Information in support of NMA

Castlewood House

This document is issued in support of a Section 96A application related to the Castlewood House planning permission (Ref: 2017/0618/P)

▲ Consented scheme typical floor

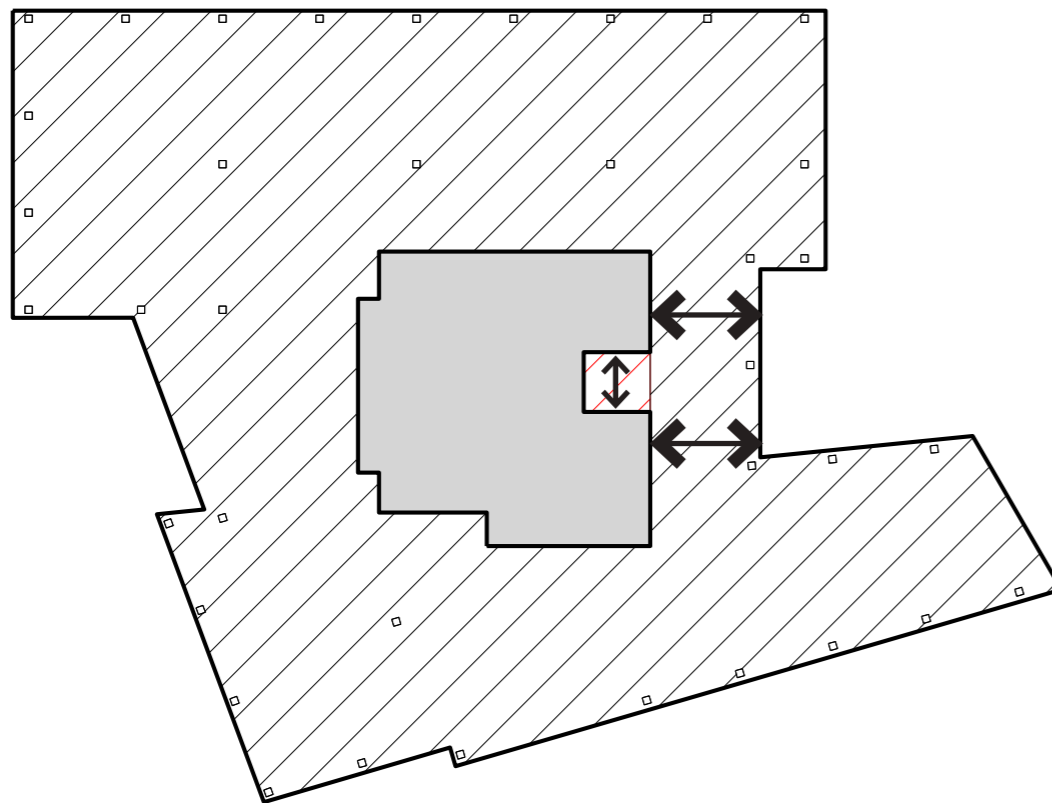
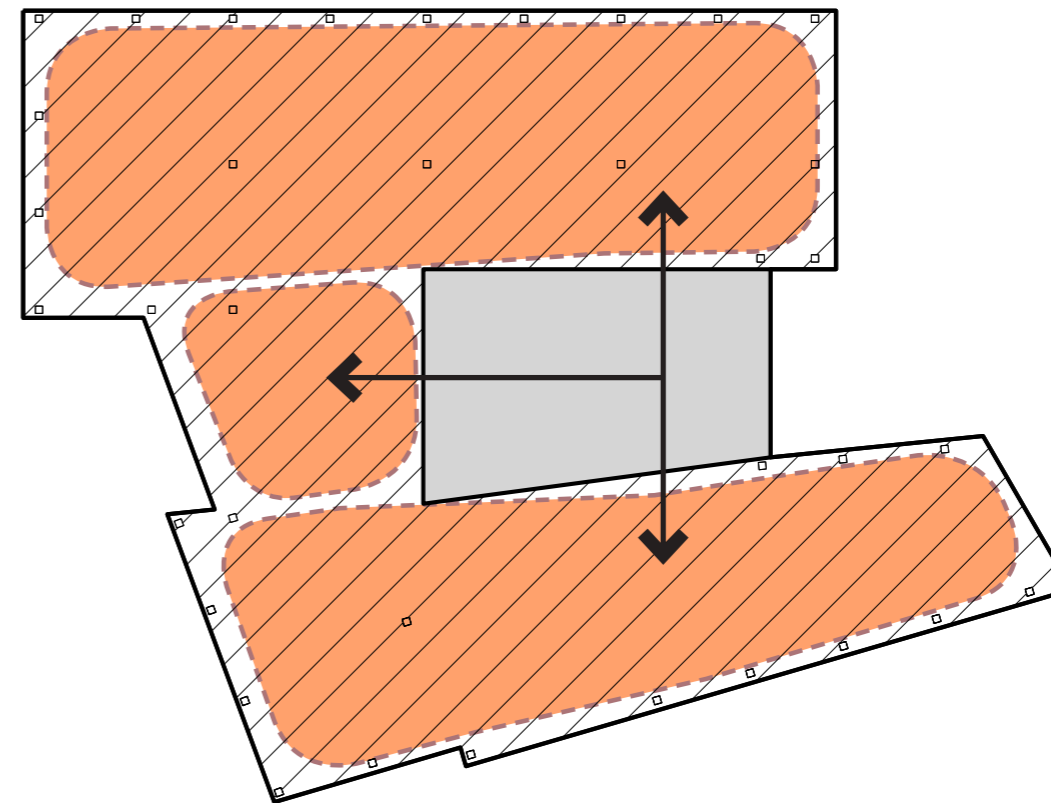
The consented scheme proposed a central core, creating a 'race track' floor plate. While this provided an efficient floorplate, it also created some areas of reduced depth to the east of the core, that were proving unable to be used effectively.

Various options were explored to improve the floorplate that tried to work within the consented scheme or minimise the impact on the consented scheme, including limiting the plant enclosure on the roof, and the quantum of basement excavation.

Of the options explored, offsetting the core to the east proved to be the preferred option as it creates a more open and usable floorplate. It also presents the opportunity to introduce natural light via a feature staircase into the lift lobby, and also daylight into the WCs, which we believe creates a more successful and pleasurable working environment.

▲ Revised scheme typical floor

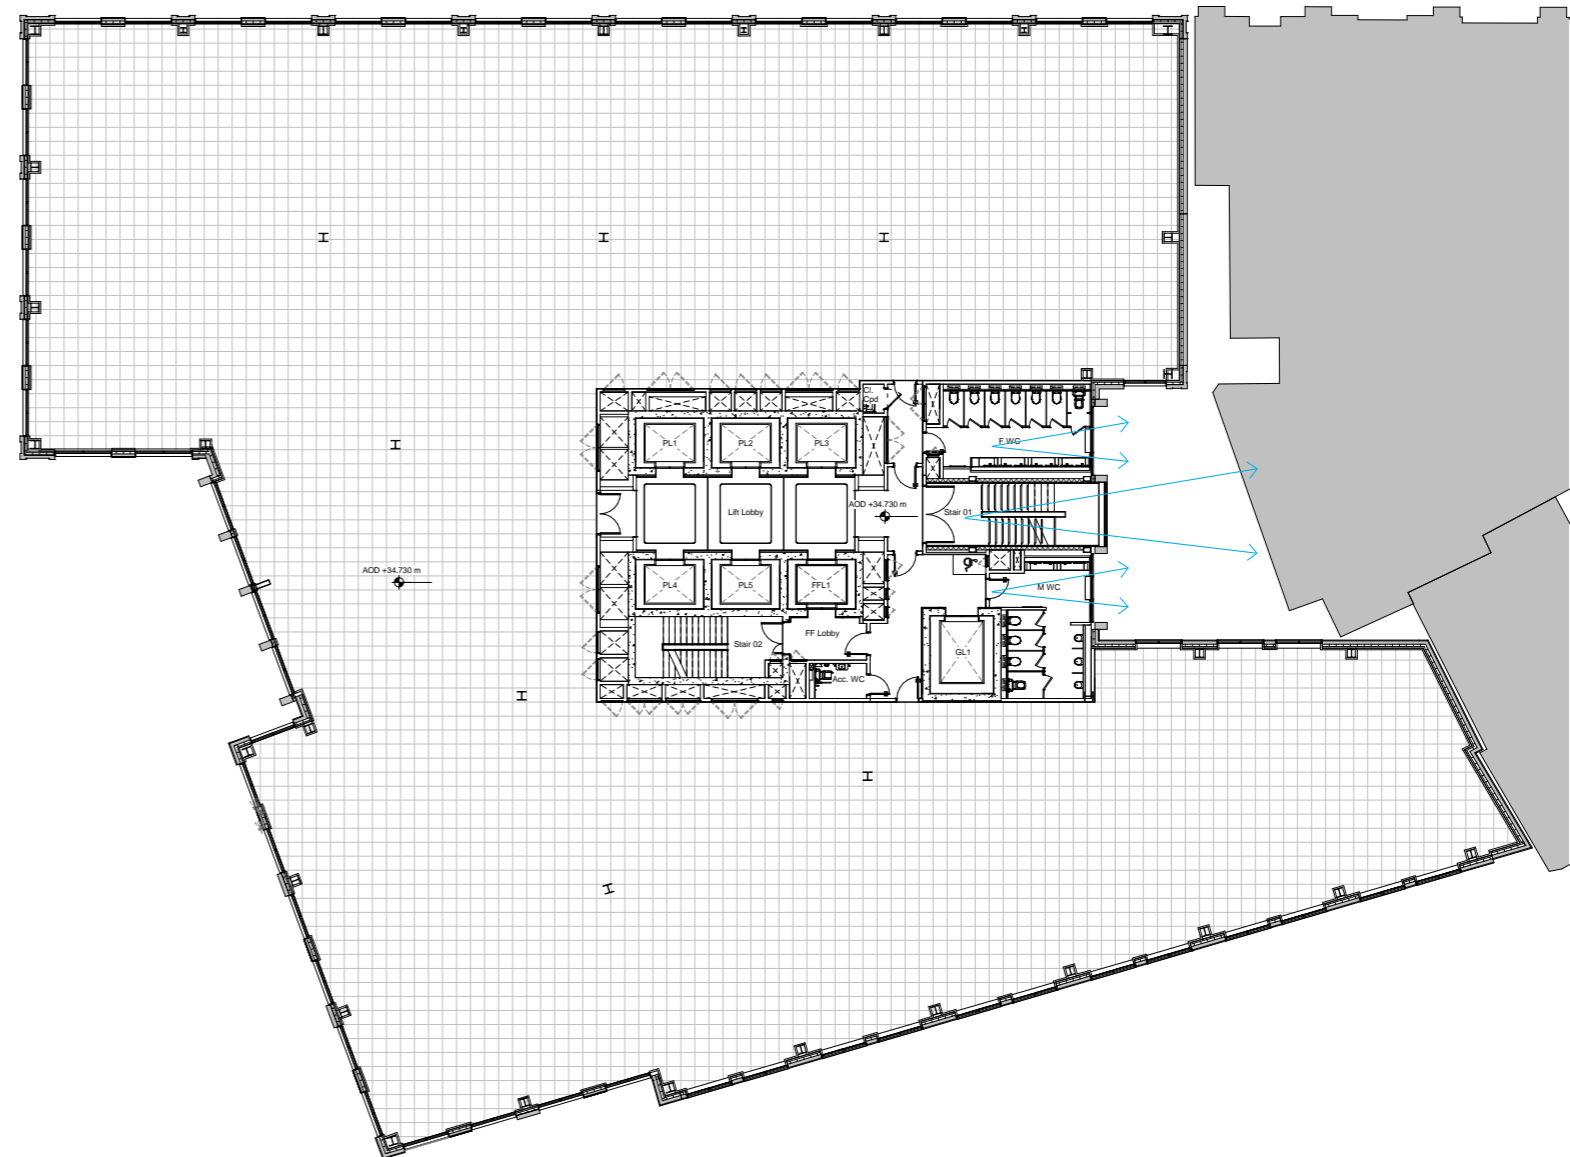
The core has been reconfigured to benefit from new location against the eastern facade. A naturally lit central feature stair is accessed directly from the lift lobby, and offers views across the site and into the external courtyard below.

The on floor lift lobbies and WC's also benefit greatly from the access to natural light, with solid elements of the facade strategically located to maintain a suitable level of privacy from the floorplate.

The revised core arrangement allows for more naturally defined tenancy splits of the floorplate, and removes the previous pinch points of the consented scheme.

▲ Proportions of elevation before realignment of adjacent facade

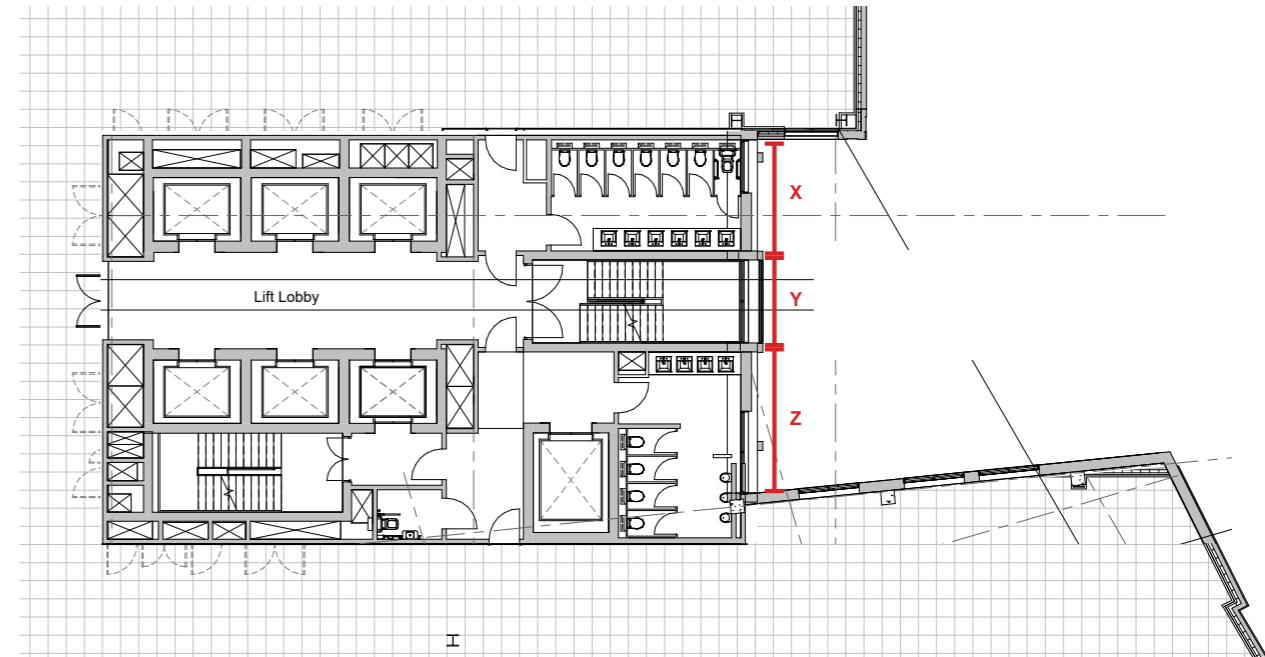
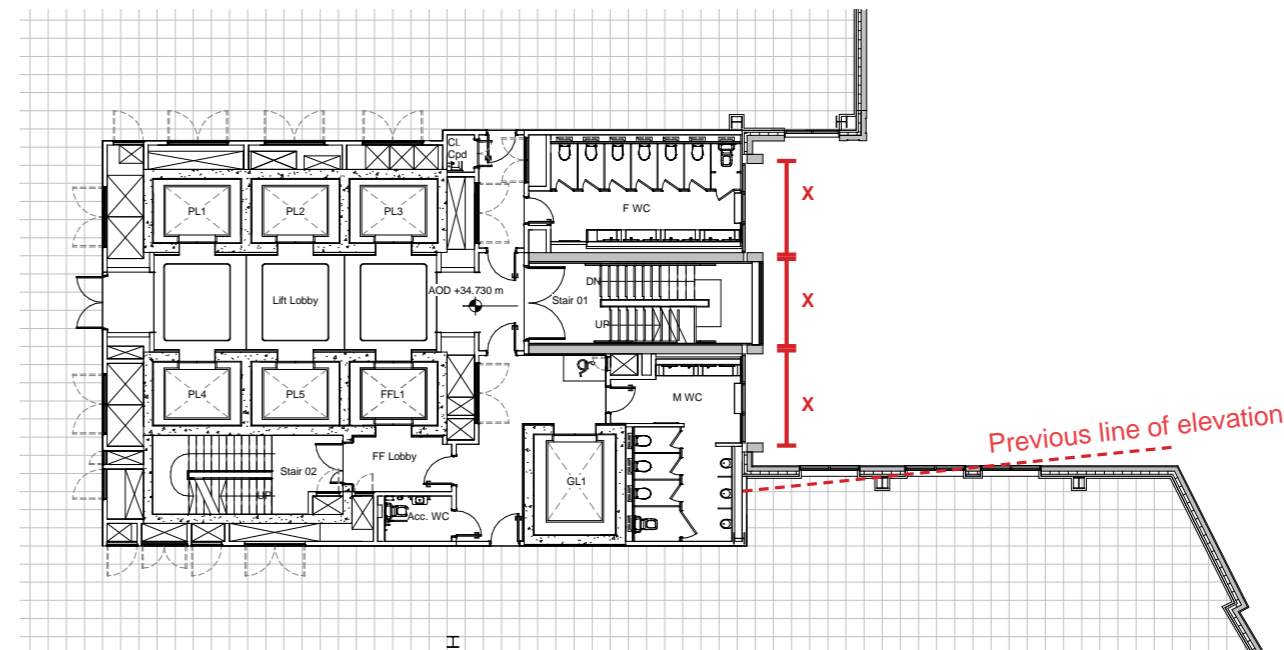
In tandem with developing the core, we have explored how this affects the composition of the eastern elevation. The revised core position and layout creates a different condition against the facade, and will require areas of opaque back-painted glass to protect the privacy of the users. The position of the stair is off centre to the consented elevation, changing the proportions of this elevation.

We initially looked at the composition of an asymmetric elevation, however this felt alien to the established language of the building. Rationalising some of the geometry around the courtyard to sit 90 degrees to the core not only creates cleaner and more logical junctions where the different elements meet, but also allows the feature circulation stair to sit central within the facade, and creates 3 equal size bays.

Adjusting the geometry to create symmetry delivers a stronger elevation. The central staircase can be celebrated, with oversized half-landings allowing people to pause and look into the courtyard.

This is the tallest element of the building and the verticality can be emphasised through the precast fins running from top to bottom. Horizontal elements such as spandrels and louvres would sit back as a secondary layer, reflecting the language of the entrance on the western elevation.

▲ Consented Ground Floor Plan

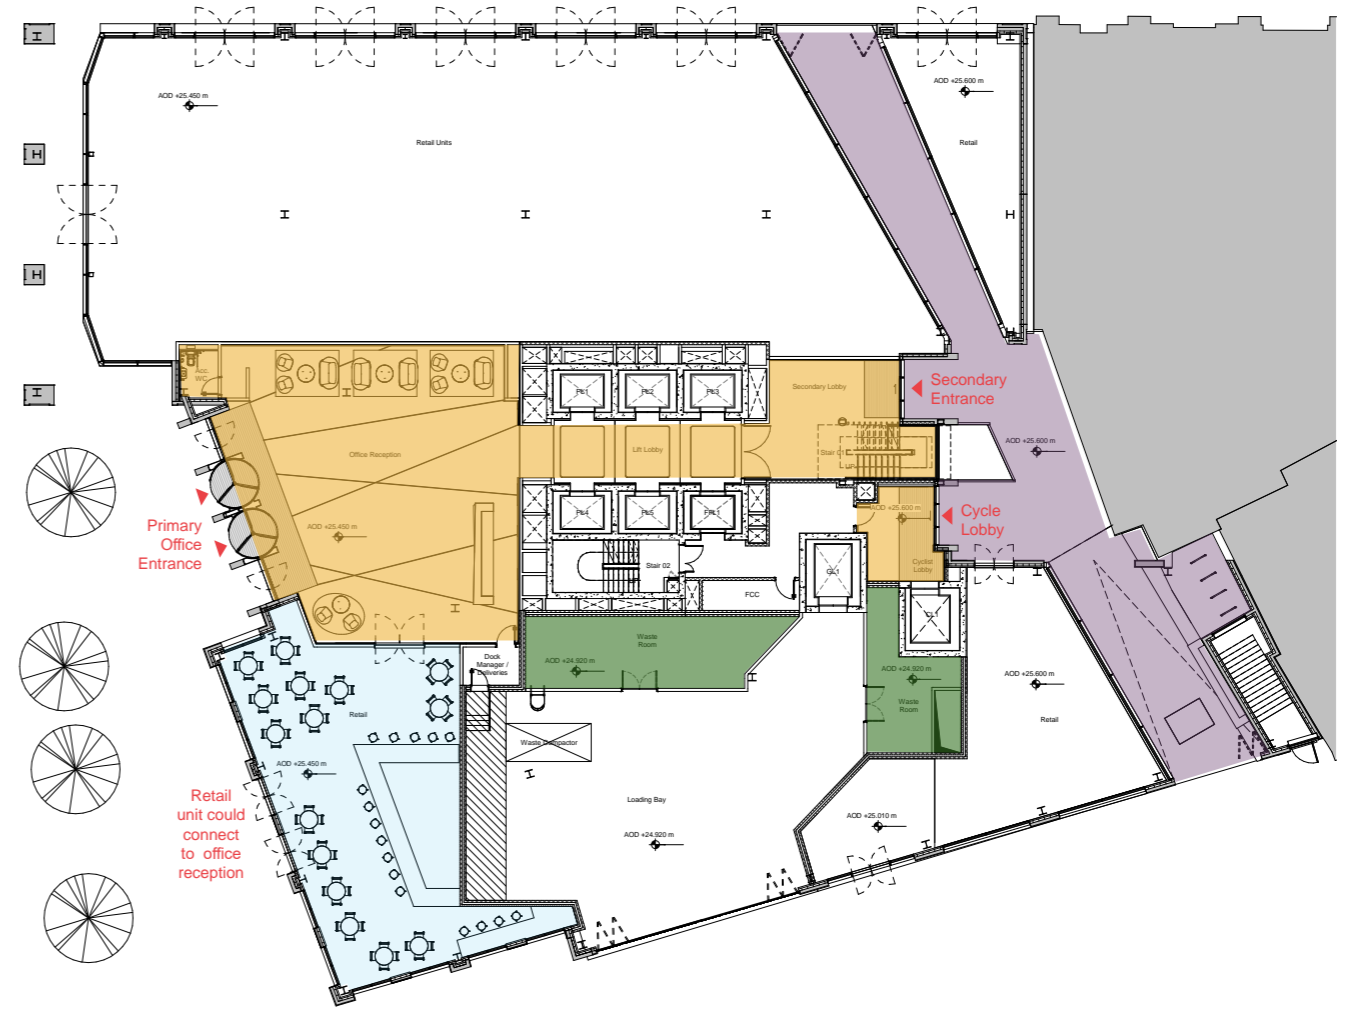
Moving the core eastwards provides the ability to rationalise the main entrance lobby, creating a deeper reception area which allows us to provide a more generous retail presence to the south west of the site. The new core position also gives the opportunity to revisit the eastern facade at ground floor and how it addresses and animates the pedestrian arcade and courtyard.

The feature stair runs all the way to the ground floor and visually connects the courtyard via the lift lobby to the main reception. To celebrate this, we have glazed more of the eastern facade and created an option for a secondary office entrance. This also removed the blank section of the facade created by the waste room, and this can now become a glazed cyclist's lobby. We feel this creates a distinct benefit to the scheme.

We have also been able to reduce the size of the void in the centre required for air to the basement plant, allowing us to create better defined entrances to the eastern facade.

Consented Scheme		Revised Scheme	
	Reception Area: 244 sqm		Reception/Lift Lobby Area: 285 sqm
	Retail Area adjacent Reception: 44 sqm		Retail Area adjacent Reception: 165 sqm
	Arcaded Pavement Area: 210 sqm		Arcaded Pavement Area: 200 sqm
	Waste Room: 75 sqm		Waste Room: 69 sqm
